East Anglia ONE North Offshore Windfarm

Offshore Ornithology Without Prejudice Compensation Measures

Document Reference: ExA.AS-~~4.D12.V4~~6.SoSQ2.V5 Tracked

05	n/a	1, 6, 7	Revisions to Section 1 and Appendices 6 and 7 in response to SoS letter
--------------------	---------------------	-------------------------	---

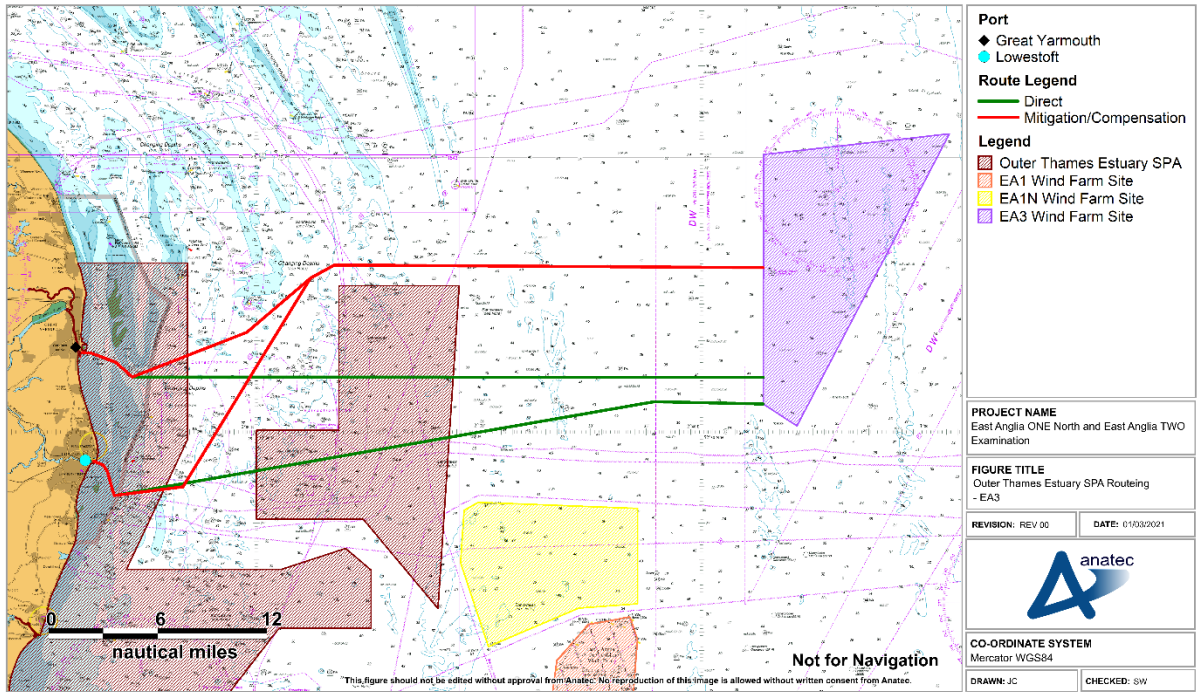
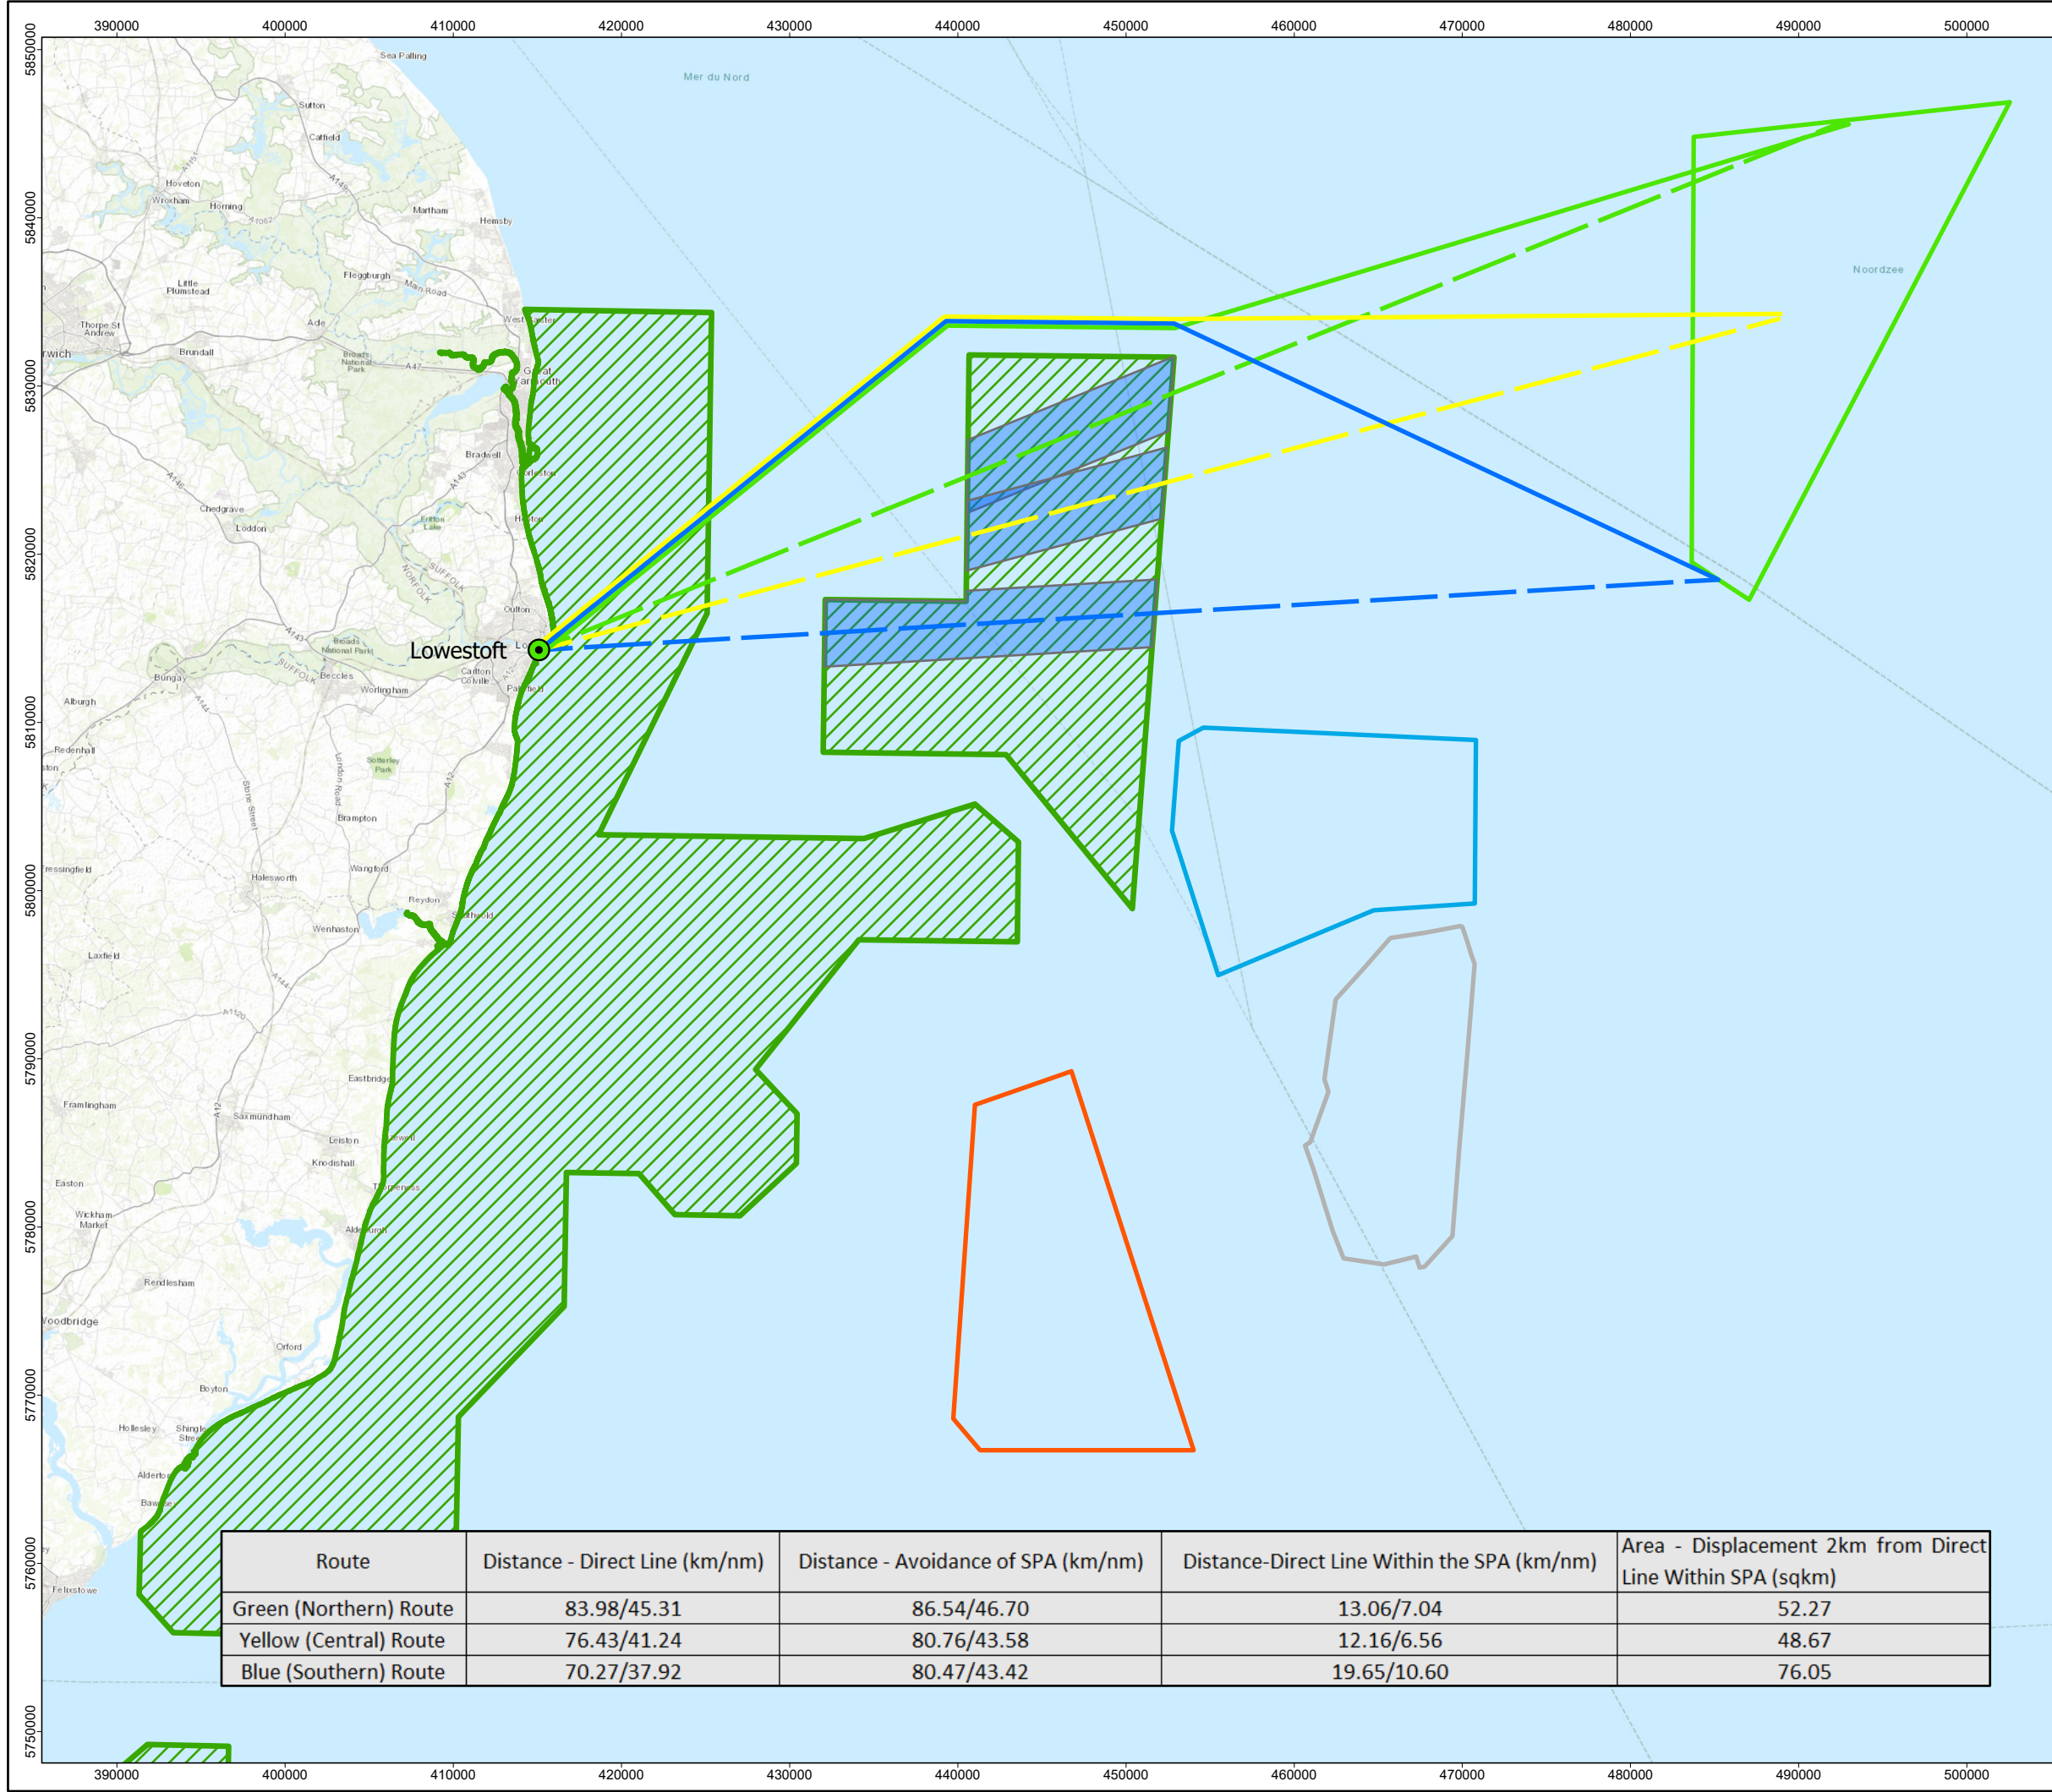
270. The results of those exercises are shown in Figure 10.1 (East Anglia THREE) and Figure 10.2 (East Anglia ONE) where the illustrative 'direct routes' that could have been taken from Lowestoft to the windfarm sites prior to this re-routing and the subsequent compensation routes are clearly shown.

~~254-271.~~ The main component of the SPA overlaps the approaches to ~~both ports~~ the port of Lowestoft and therefore it is not possible to avoid transiting through this part of the SPA. However, the re-routes have been specifically created to follow the navigation approaches to ~~both ports~~ the port, and thus limit the impact of the Projects' projects' vessel movements to areas of existing navigation routes associated with ~~the ports, where the densities of red-throated diver are typically relatively low~~ Lowestoft.

272. For East Anglia ONE the vessels use the same re-routing from Lowestoft as for East Anglia ONE North and East Anglia TWO, vessels have been routed avoiding the seaward section of the main component of the SPA by routeing through the gap between the main component and northern component of the SPA. This gap generally allows for a 4km width, with the exception at its narrowest where the gap is orientated northwest-southeast for a short section. At the point the gap is reduced to between 2.75 and 3.30 km, preventing a full 4km width. It should also be noted that alternative mitigation routes could also be used, but avoidance of the SPA (as shown on Figure 10-2).

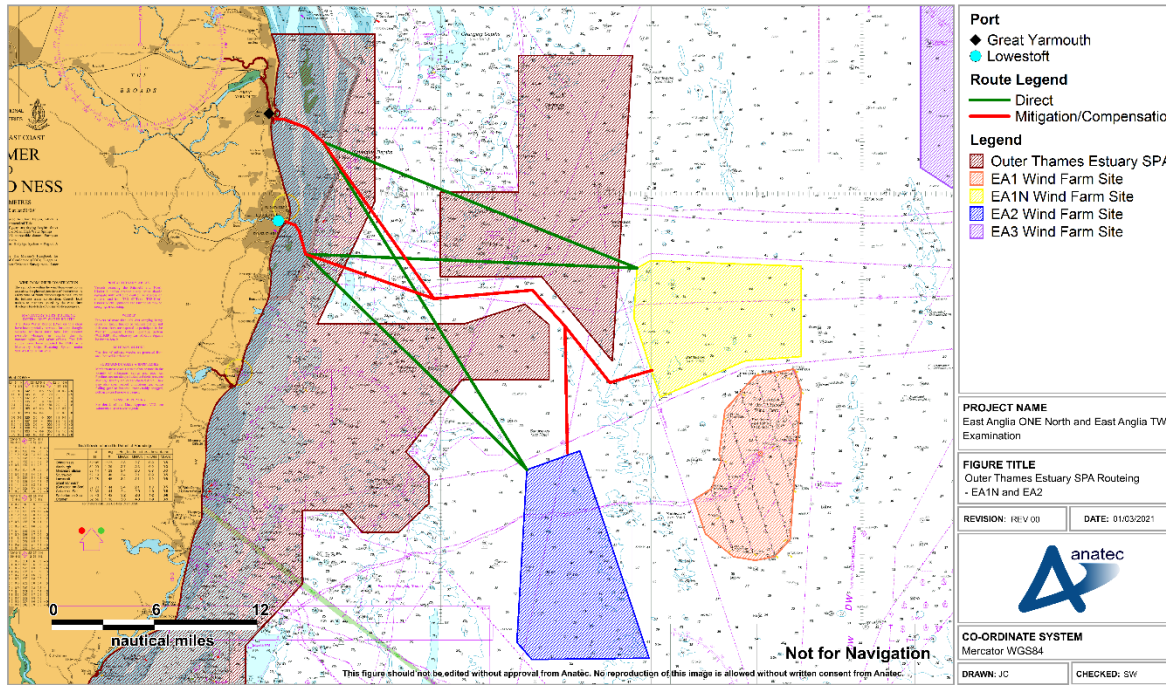
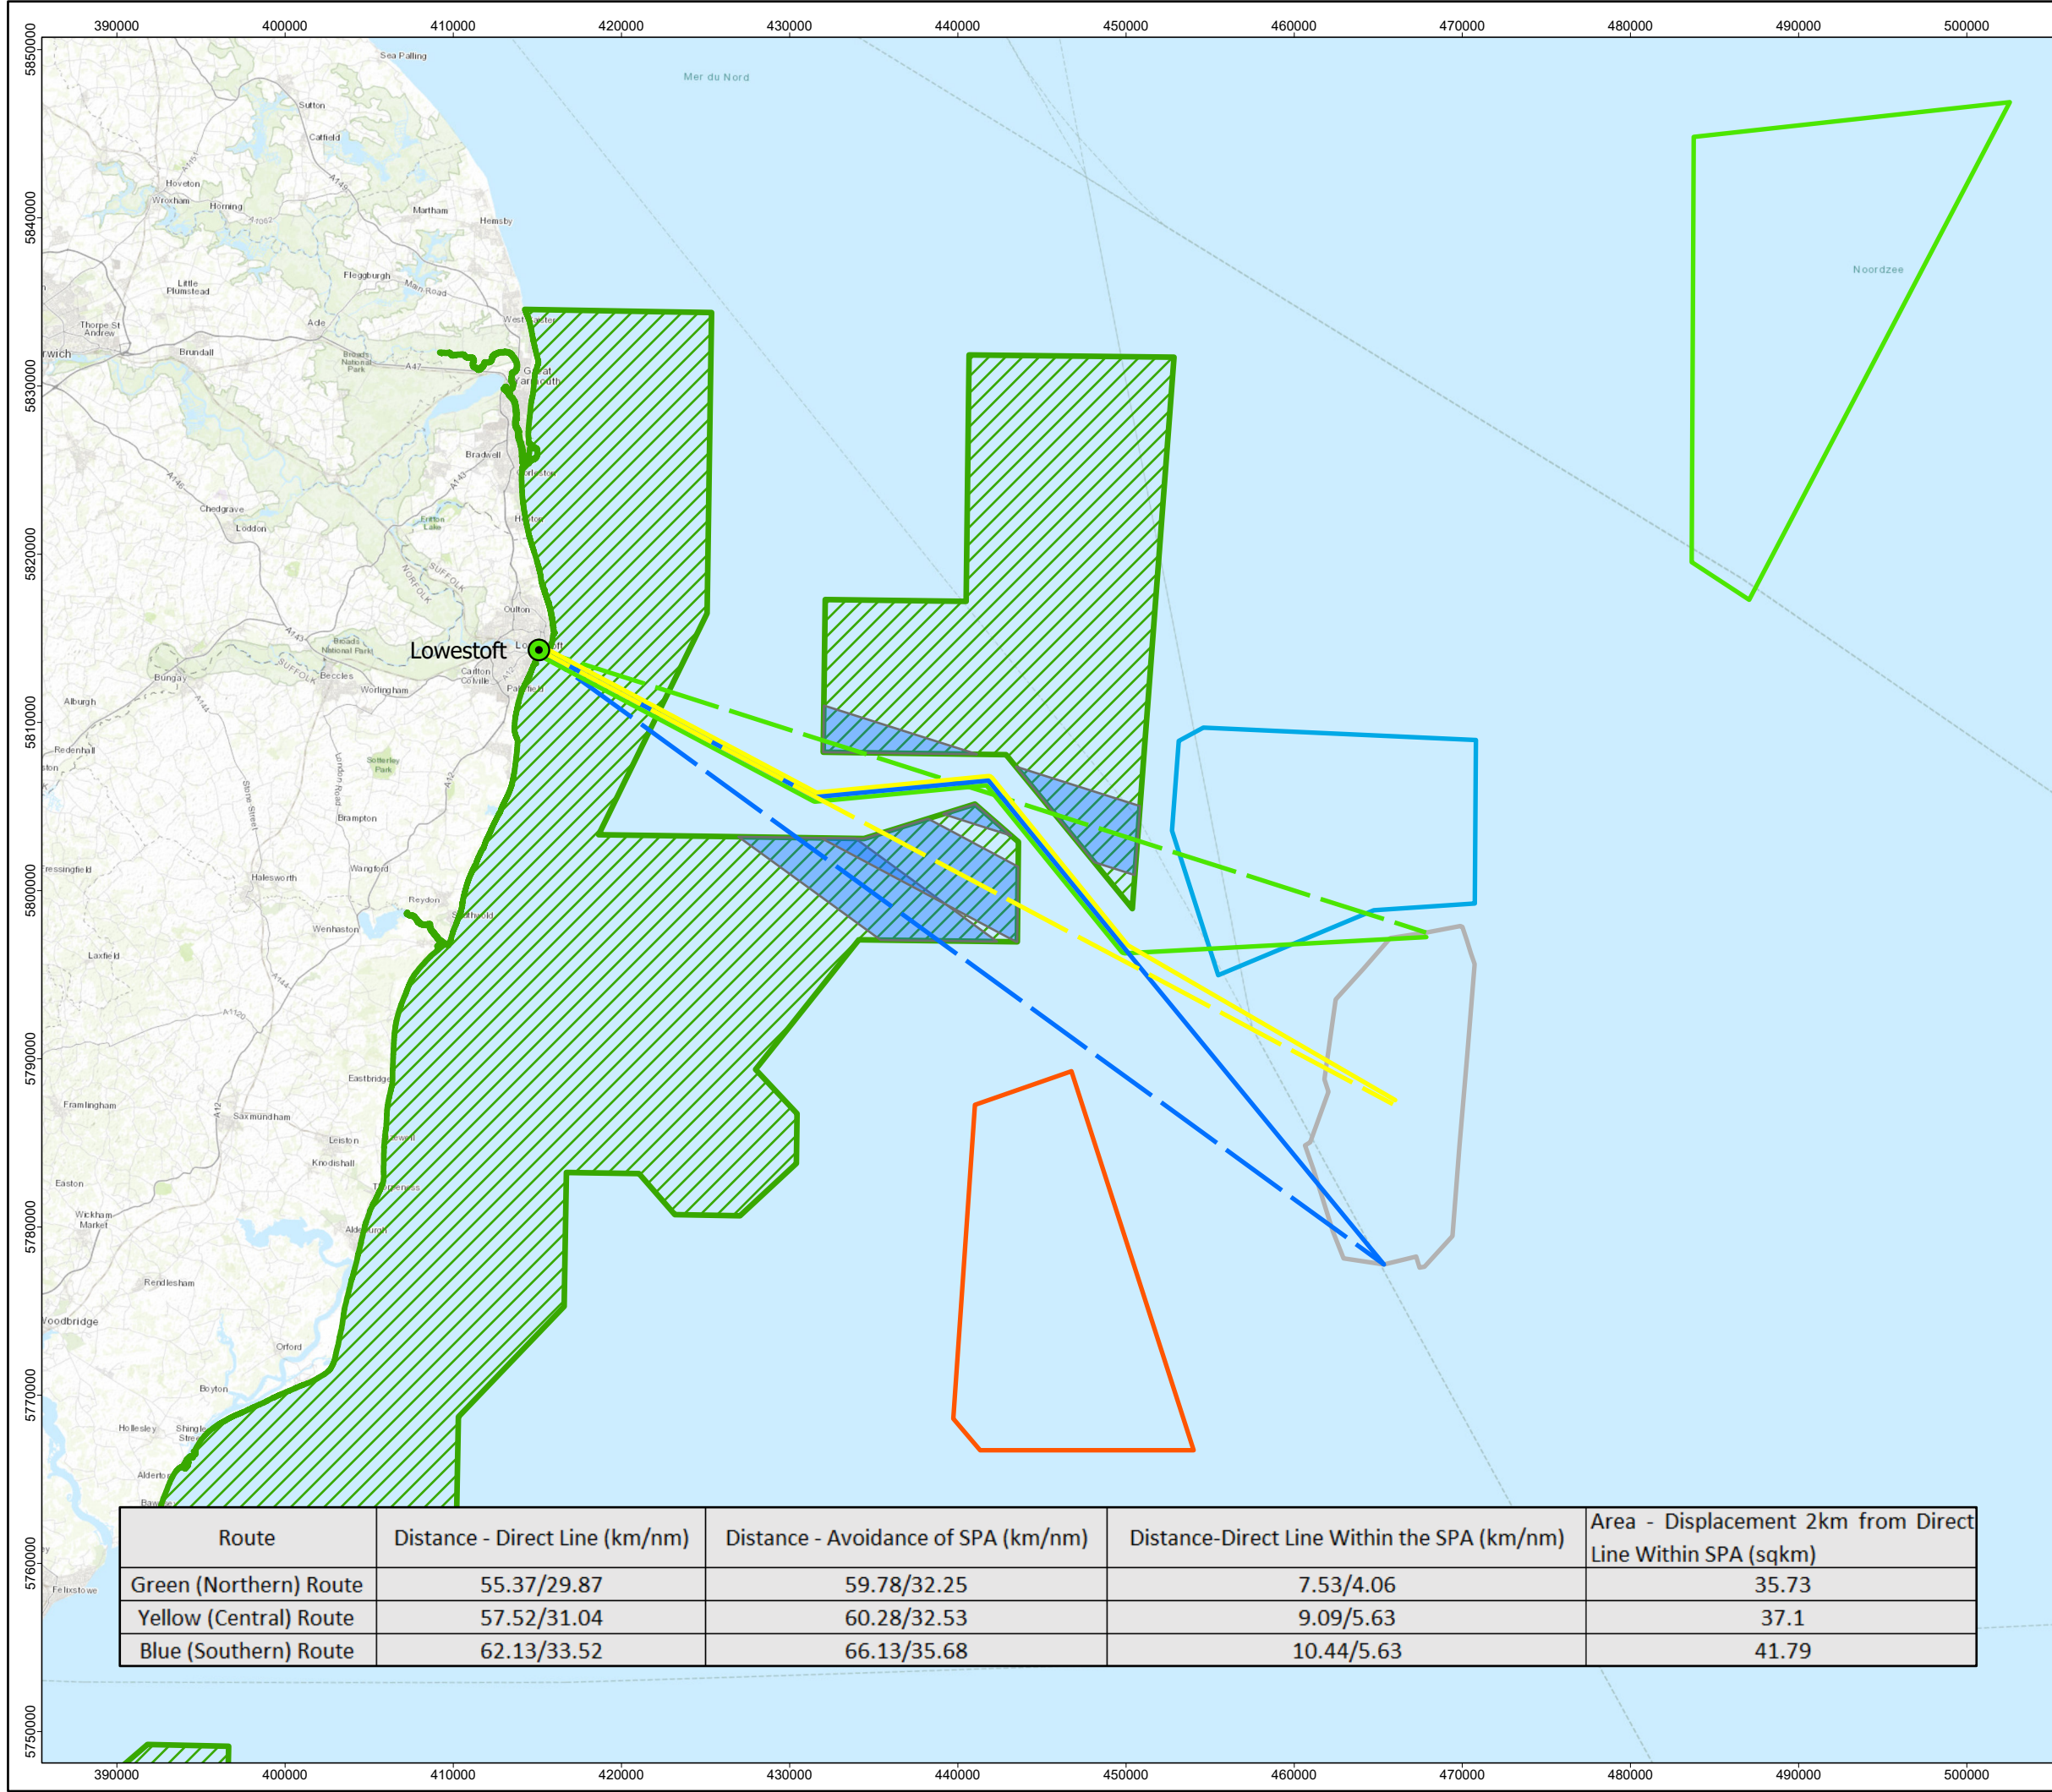
~~256-273.~~ Once beyond the main component of the SPA, vessel traffic from Lowestoft to and from East Anglia THREE has been re-routed to avoid the northern component of the SPA ~~beyond the approaches to the ports would be maintained.~~ (as shown on *Figure 10-1*).

277. The EA1N Offshore Ornithology Without Prejudice Compensation Measures document (REP12-060) explained that re-routing of operation and maintenance vessels between Lowestoft and East Anglia THREE would reduce a frequent temporary impact of approximately 80km². The basis of this calculation was explained in REP12-060 under **paragraph 260** and **Figure 10-1**:

*“The northern component of the SPA is approximately 20km at its widest point in the south and approximately 12km at its narrowest point in the north. The direct route between the operation and maintenance port at Lowestoft and the East Anglia THREE windfarm site passes through the widest part of the northern component as shown in **Figure 10-1**. Assuming a 4km displacement area centred on the direct route gives an area of approximately 80km² that would be avoided on a daily basis by operation and maintenance vessels taking the direct route. This compares with a total effective area of the SPA estimated to be subject to displacement of between 16km² and 19km² (using the Applicants model results) or 54km² (using the NE approach). For construction vessels taking the direct route between Great Yarmouth and East Anglia THREE, the area of the SPA that would be avoided would be approximately 48km².”*
